ADDENDUM NUMBER THREE
TO THE CONTRACT DOCUMENTS FOR CONSTRUCTION OF
ORANGE BEACH RECREATION COMPLEX
NEW BASEBALL/SOFTBALL FIELD RENOVATIONS AT ORANGE BEACH SPORTSPLEX
CITY OF ORANGE BEACH

This addendum forms a part of the Contract Documents and modifies the Bid Documents dated May 4, 2020.

This Addendum consists of three (3) page Addendum, one (1) general documents, one (1) Specification & thirteen (13) full-size sheets.

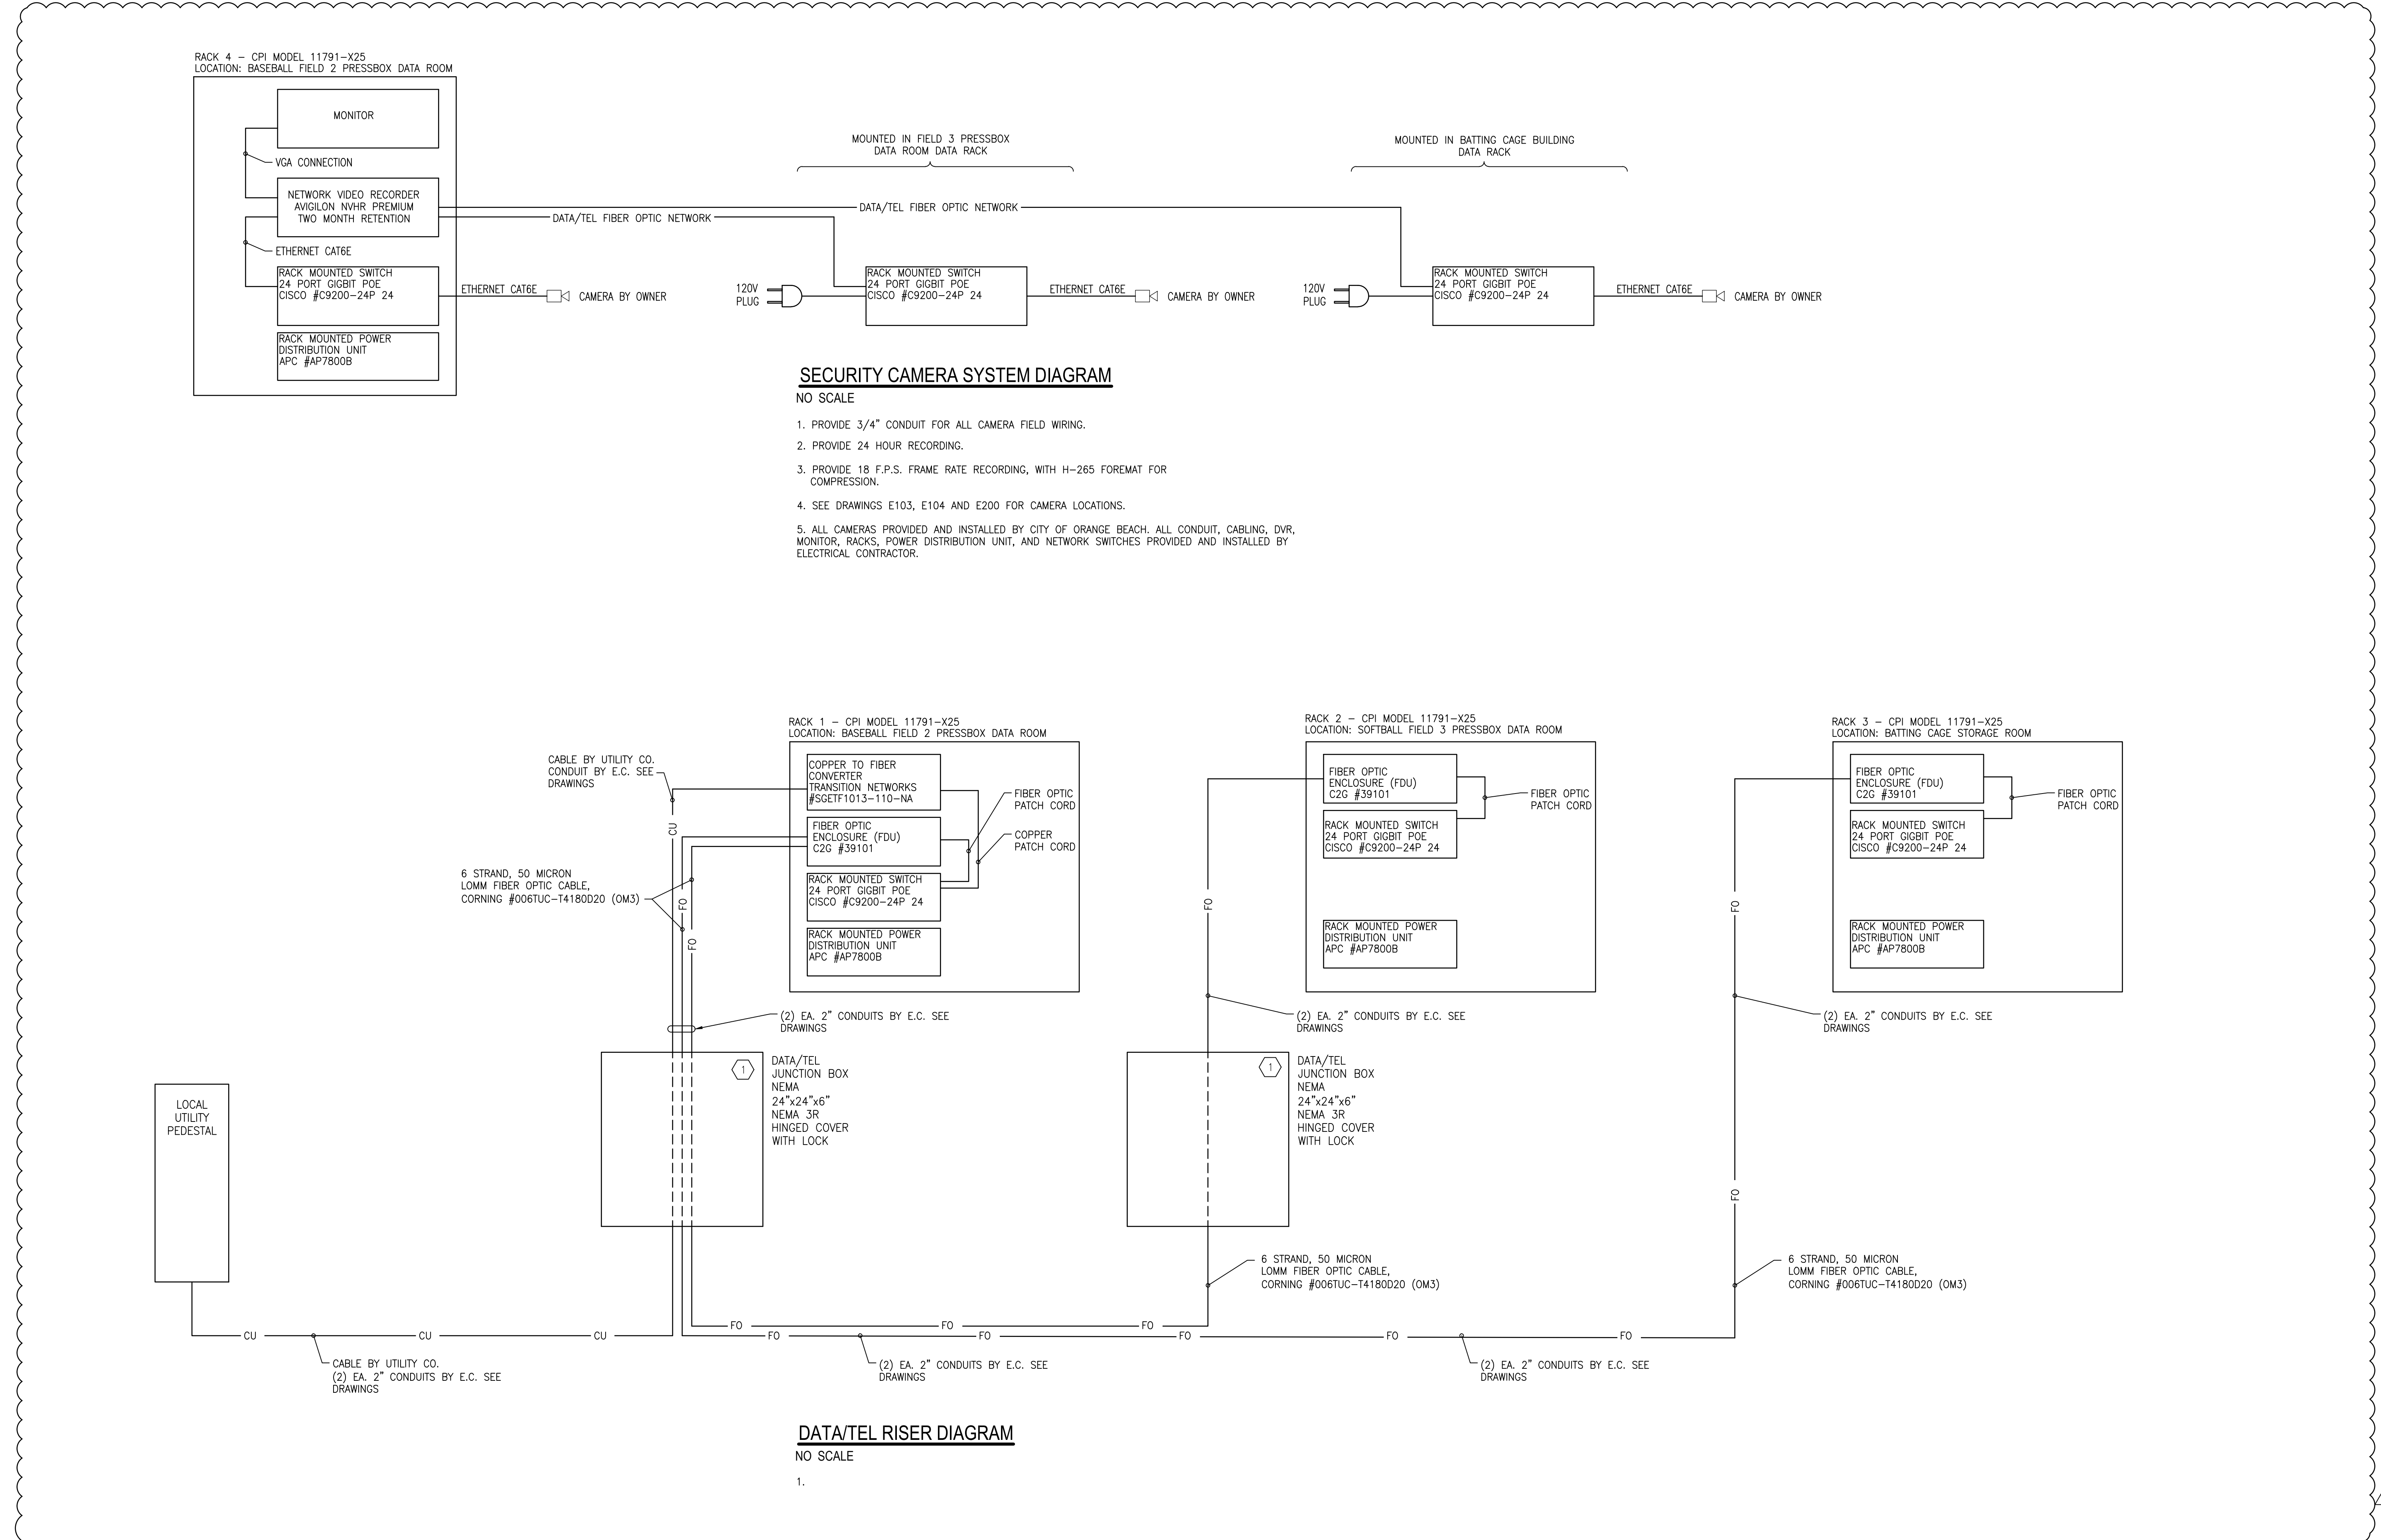
ITEM 13 SHEET E501 – DATA/TEL RISER DIAGRAM

1. Added model numbers for rack equipment on the Security Camera System Diagram.
2. Added notes on the Security Camera System Diagram referencing drawings with camera locations, and note describing what bidders are to include and exclude.
3. Added fiber-optic cable manufacturer and model number.
4. Added model numbers for rack equipment on the Data/Tel Riser Diagram.
